24 August 2026

RE: A006940193/184 & 198 GARDNER RD & 56 FARLEY RD, ROCHEDALE, 4123 - RESPONSE TO INFORMATION REQUEST

Figure 3: Access locations to Waterway Fringe (shown by blue star)

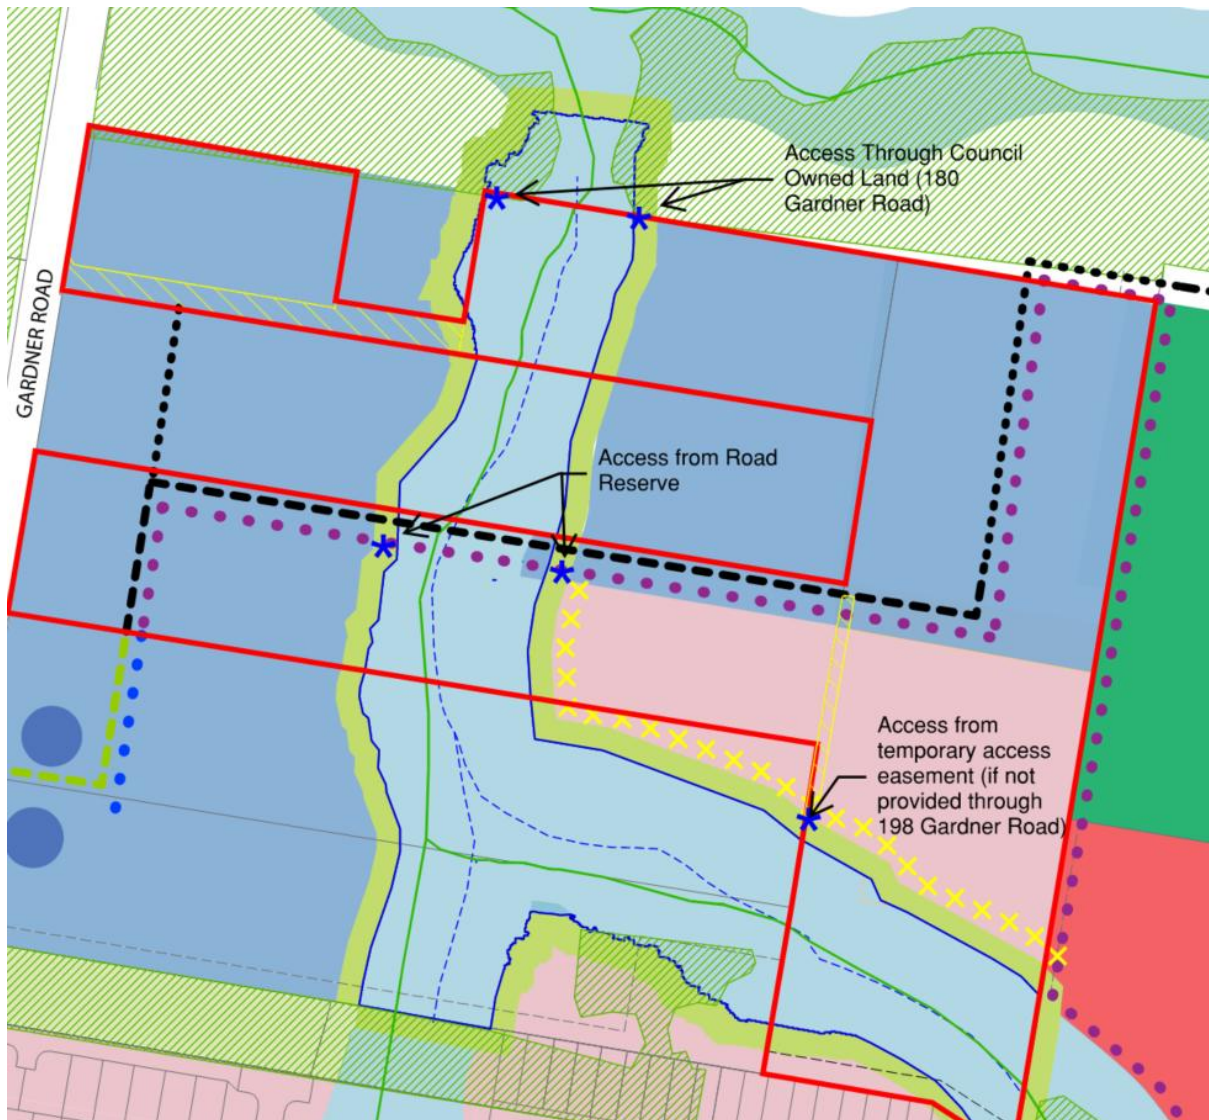
d. Further information on access to the fringe on each part of lot 800.

Access to the southern part of the waterway (i.e. to the south of the residential area approved under A005747839) can be provided via a temporary access easement (as conditioned under A005747839) until the land to the west (202 Gardner Road, Rochedale) or the land to the east (323 Rochedale Road, Rochedale) is developed. It is noted that each of these parcels have active development applications and/or approvals of the subject land.

This is demonstrated in Figure 3 below.

Figure 6: Excerpt of Functional Layout Plan

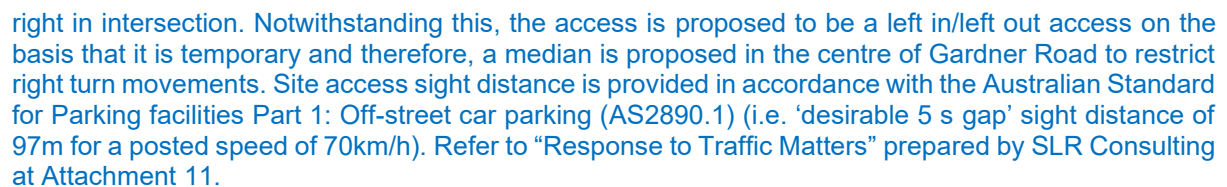
- b. The provided SIDRA analysis of the interim access to Gardner Rd identifies that the right turn egress would become difficult in future year 2034 and recommends access be limited to left in / left out only (left turns remaining within capacity in future year 2038). Provide revised plans to demonstrate left in / left out operation of the interim access;**

- c. Submit concept traffic functional layout plan to demonstrate safe temporary access from Gardner Road and proposed associated roadworks;**

A turn warrant assessment has been prepared by SLR Consulting for the proposed Lot 17-19 access which has determined that a Basic Left (BAL) turning treatment along Gardner Road is appropriate to provide access. It is noted that the Traffic Impact Assessment prepared and lodged as part of the common material supporting the development application, it identifies that this intersection is able to function as an all movement intersection up to 2034, whereby it would be reduced to a left in, left out,

Figure 8: Proposed Culvert Design. Cyan culverts = 3600W x 1500H Dry Culvert, Green culverts = 3600W x 1725H dedicated Fauna Movement Culvert, Blue culverts = Fish Passage Culvert

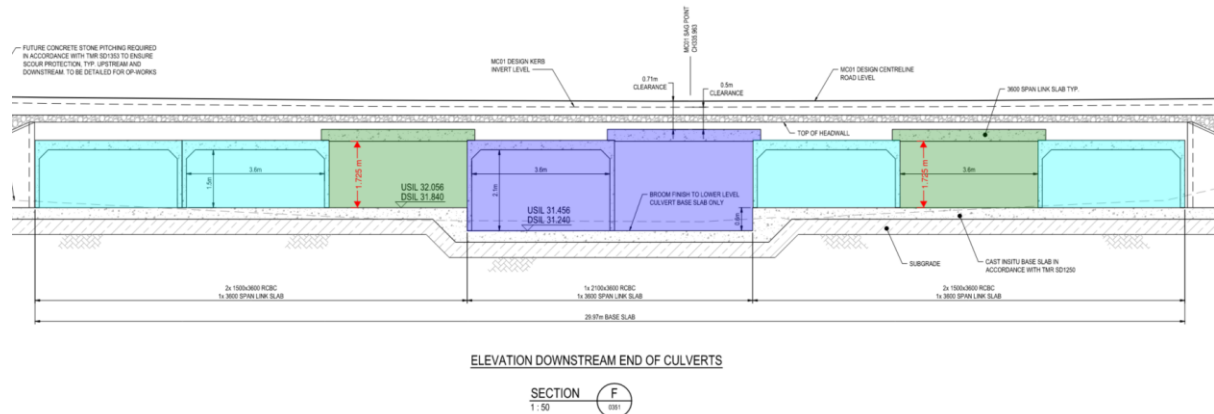
16. Provide details for creek crossing structure under the new road based on revised flow analysis. The design of the culvert needs to balance flood management, ecological requirements, waterway health, asset maintenance/replacement and construction costs. The following items are to be provided:

- a. *The main channel culverts are to be constructed using box culverts with link slabs between. This will allow for riprap natural base where link slabs are located and reduce costs;*
- b. *The culverts need to allow for fauna movement (both terrestrial and aquatic). This will require a wet/dry cell arrangement;*
- c. *The culverts need to allow for fauna movement (both terrestrial and aquatic). The use of 1500mm high culverts needs to be determined to be suitable by ecology. The culvert design must provide for dry and wet culvert cells; and*
- d. *A culvert general arrangement plan with concept sections needs to be provided clearly showing that the proposed crossing can fit within the existing creek channel without significant widening and unsafe batters needing to be created.*

- 2 x 3600W x 2100H 'wet culverts' along the waterway centreline. These culverts are intended to provide fish passage and have been designed in consideration with the Water Barrier Works Accepted Development Requirements.
- 4 x 3600W x 1500H culverts (dry) providing flood water conveyance capacity in the waterway and fauna movement opportunities. These culverts provide dedicated fauna movement opportunities on each side of the waterway.
- 2 x 3600W x 1725H link culverts (dry) providing fauna movement including fauna movement ledges and poles, and flood water conveyance capacity in the waterway.

Refer to Figure 8 below and the "Engineering Response" prepared by Arcadis in Attachment 9.

Figure 11: 1% AEP line in relation to the waterway corridor and works

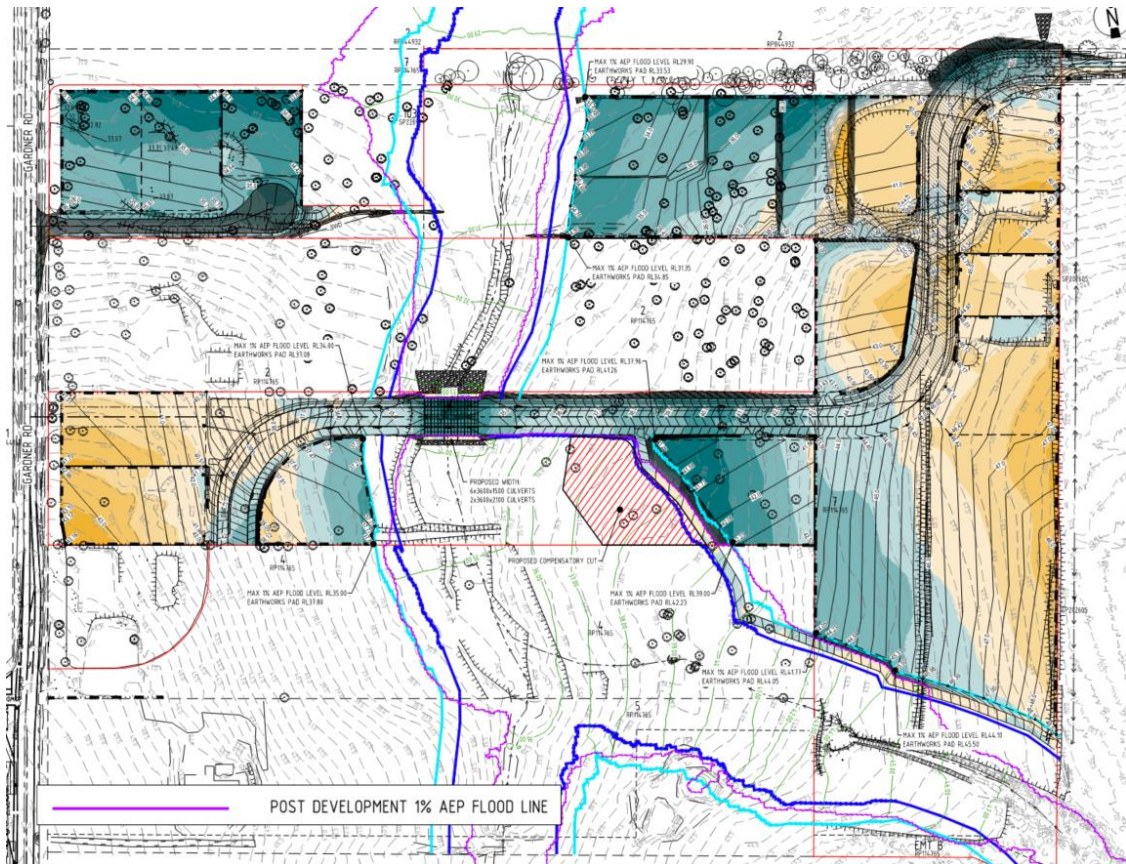
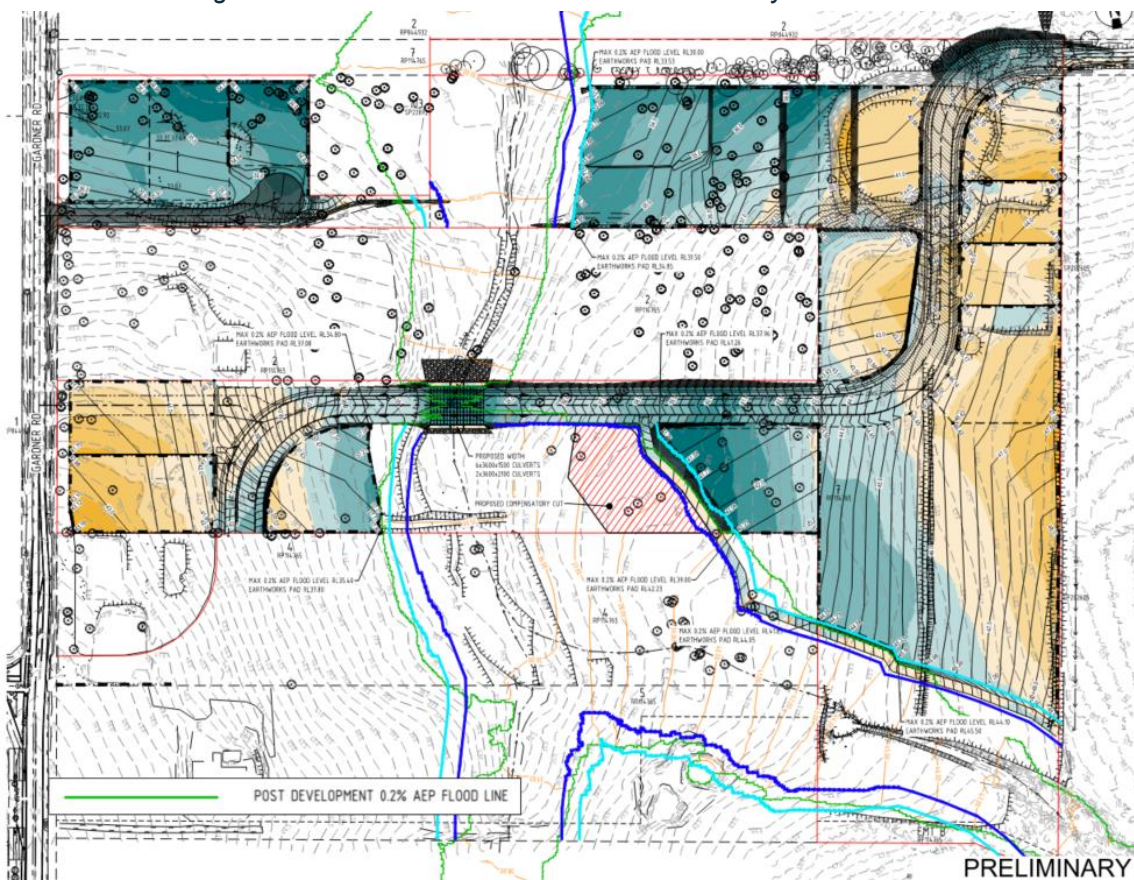
- 18. Provide supporting flood study demonstrating flooding is contained within the waterway, culverts convey 1% AEP flows, and lots have flood immunity. Flood study to allow for AR&R climate change and fully upslope developed conditions in the analysis and input flows from the site into the creek at the culvert and downslope boundary of the site based on proposed pipe discharge locations. The following must be also addressed;**

- b. The 2016 Australian Rainfall & Runoff (AR&R) data hub information is now outdated. Obtain the LIMB 2020 (or newer where available) rainfall data from City Projects office;**
- c. Update culverts to required sizing/arrangement for fauna movement and design the culverts for a maximum 30% blockage;**
- d. Provide flood level maps showing contours for 1% AEP flood and confirm all lots are >300mm above the 1% AEP flood level;**
- e. Provide culvert outlet velocity as modelled and ensure <2.5m/s even where riprap is provided; and**
- f. Model AR&R climate change RCP4.5 (or equivalent factoring of flows) as a separate model scenario and ensure the waterway contains this flooding up to 0.2%AEP event and ensure lots are at least 300mm above this level.**

The 1% and 0.2% flood level is not contained within the waterway at the northern end of waterway due to undefined bank and minimum grades in the northern section of the waterway. This is not a result of the development, whereby the extent of flooding in the 1% and 0.2% AEP is the same (no change) under the pre-development scenario. The extent of flooding is a product of updated LIMB2020 data and results in flood water spreading out over the land at 103 SP226721 and Council owned land before the waterway junction. The depth of flood water is less than 0.5m and slow moving (<1m/s). It is not considered necessary to change the waterway alignment through the northern part of the waterway.

Figure 11 and 12 demonstrate the 1% and 0.2% flood line in relation to the proposed development extent, demonstrating that each lot achieves flood immunity in the 1% and 0.2% events.
